Design Review Report – Item 1

Item no.: Item 1 – DA25/1020 – 24 Milldale Way, Mirrabooka – Development Application – Mixed Use – Nine Commercial Tenancies and 16 Multiple Dwellings

Design quality evaluation
Item 1 – DA25/1020 – 24 Milldale Way, Mirrabooka – Development Application – Mixed Use – Nine Commercial Tenancies and 16 Multiple Dwellings
DRP Meeting – Thursday 26 February 2026

SOLAR & VENTILATION DIAGRAM PLAN

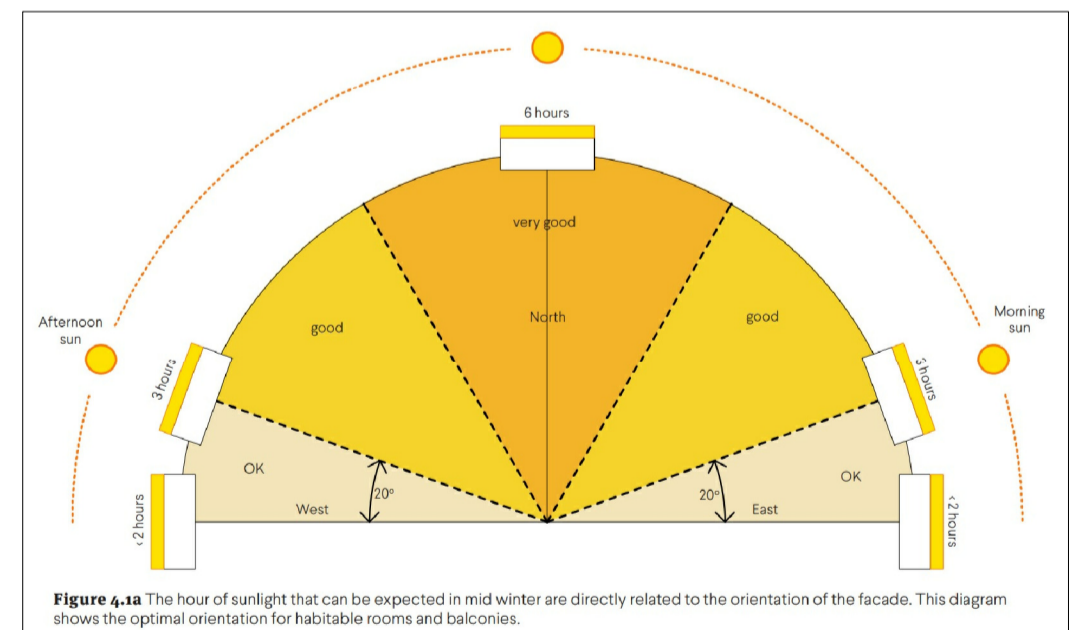
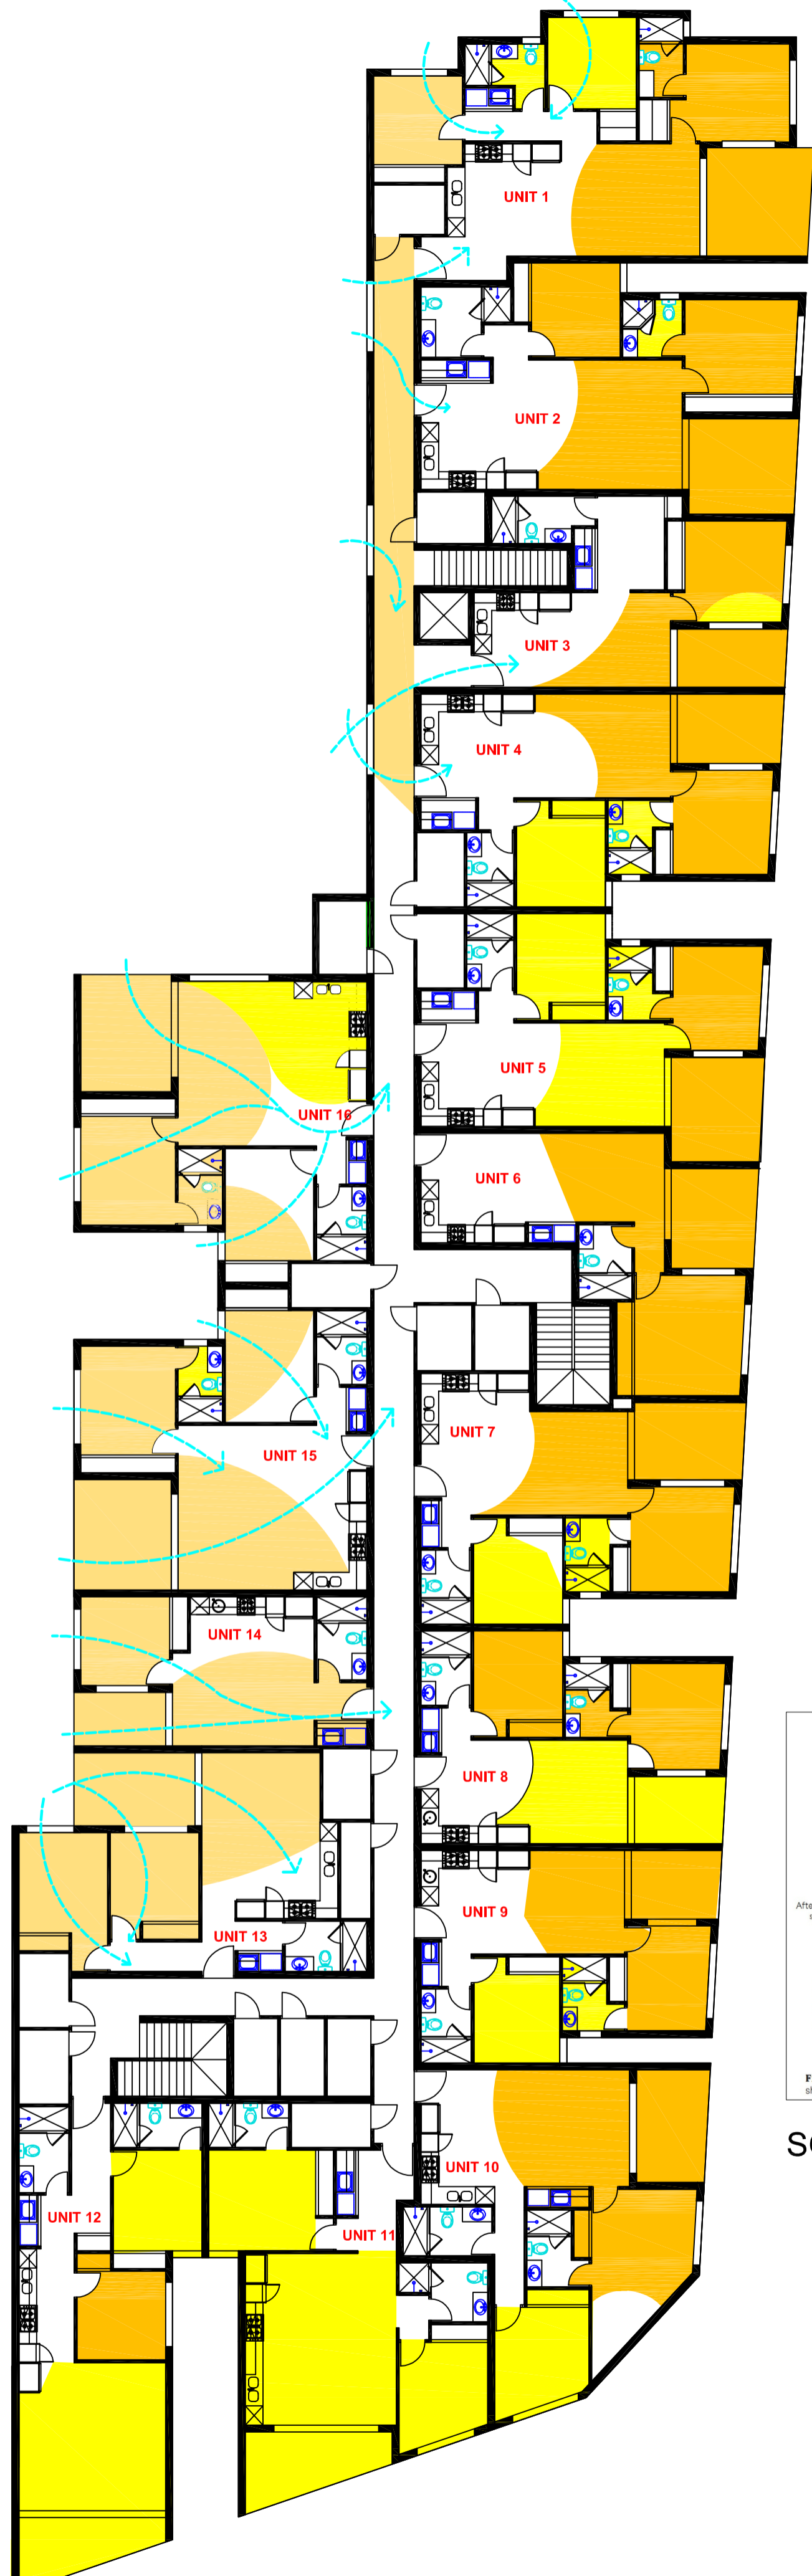
- 6b. The current solar access diagrams are confusing as the colour coding key varies between units and is applied inconsistently. Further to the Panel’s recommendation to revise the residential planning, provide supporting and accurate diagrams on the access of natural amenity (breeze flow, daylight and mid-winter solar access) into the habitable rooms of each apartment

MILLDALE WAY VIEW

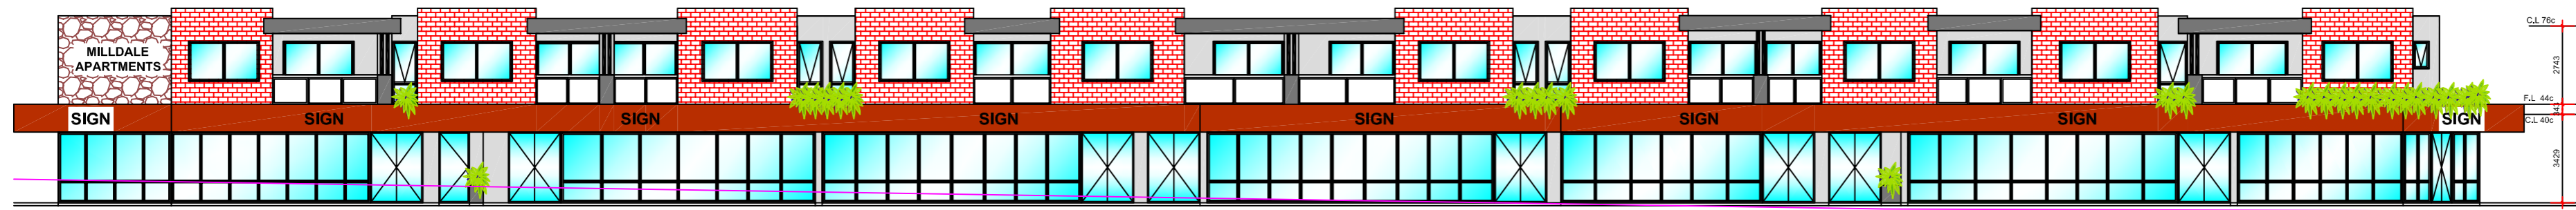
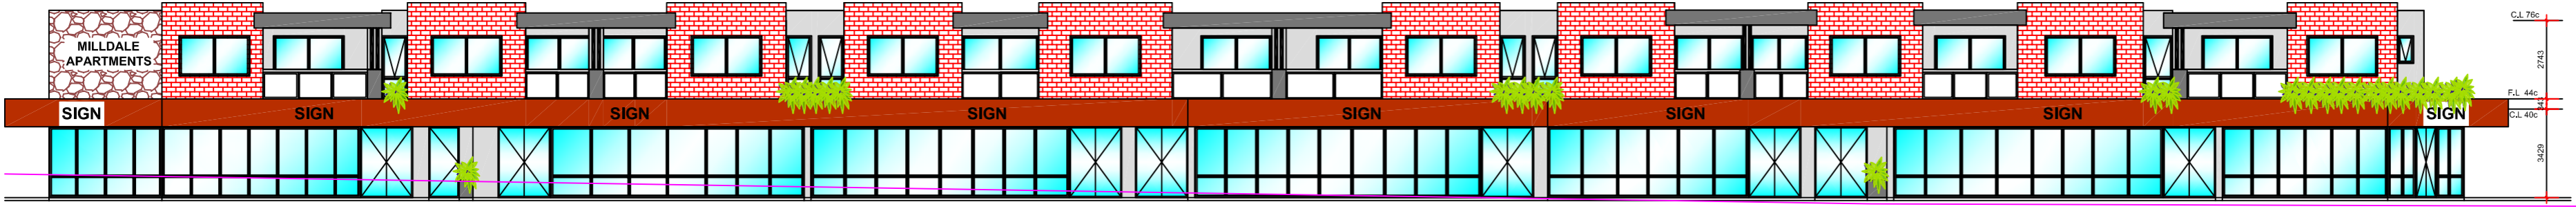
<p>station). Consider greater articulation of the elevation through finer-grain detailing and greater diversity of materiality.</p> <p>10b. The street front elevations include an overly complex materials and colours palette. Consider simplification and a clear rationale for the palette (note: brick and stone are load bearing materials that shouldn't be applied randomly, as in this case at the upper level).</p> <p>10c. The shopfronts read as very commercial facades. Consider introducing finer grain materials, breaking up the fenestration design and provide opportunities for each business to personalize their facade.</p> <p>10d. As public art is a mandatory component of the development, consider artwork at an early stage that is appropriately located and will contribute meaningfully to the development as well as the surrounding context within the Mirrabooka Town Centre.</p>			
--	--	--	--

REAR VIEW

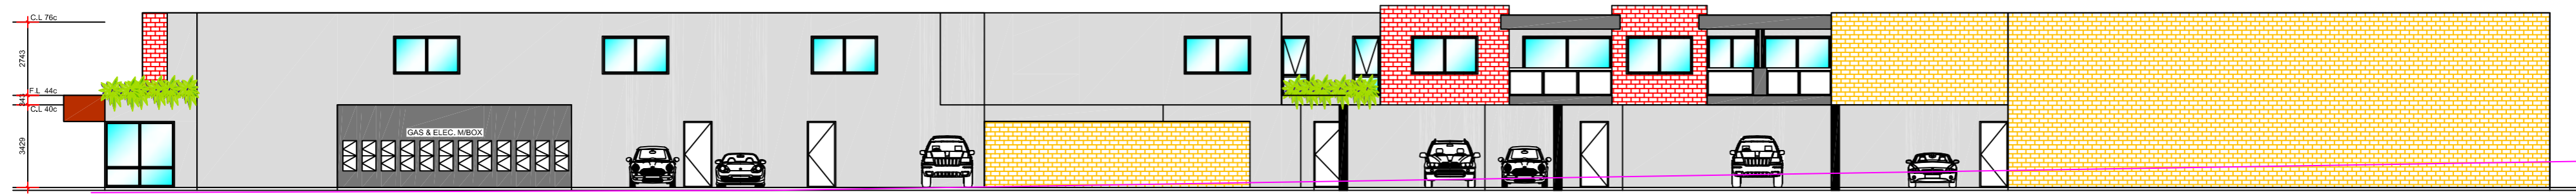
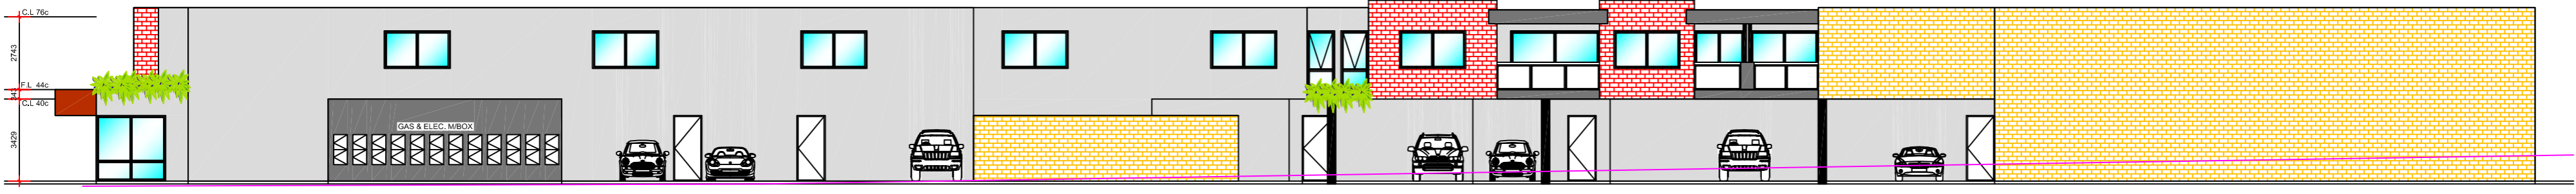
<p>8a. Refer to the comments above in Principle 7 – Legibility, given legibility and safety are connected and Principle 4 – Functionality and Build Quality.</p>			
<p>10a. The rear south-western elevation appears flat and unfinished with little visual interest (the rear is visible from the adjacent Bus</p>
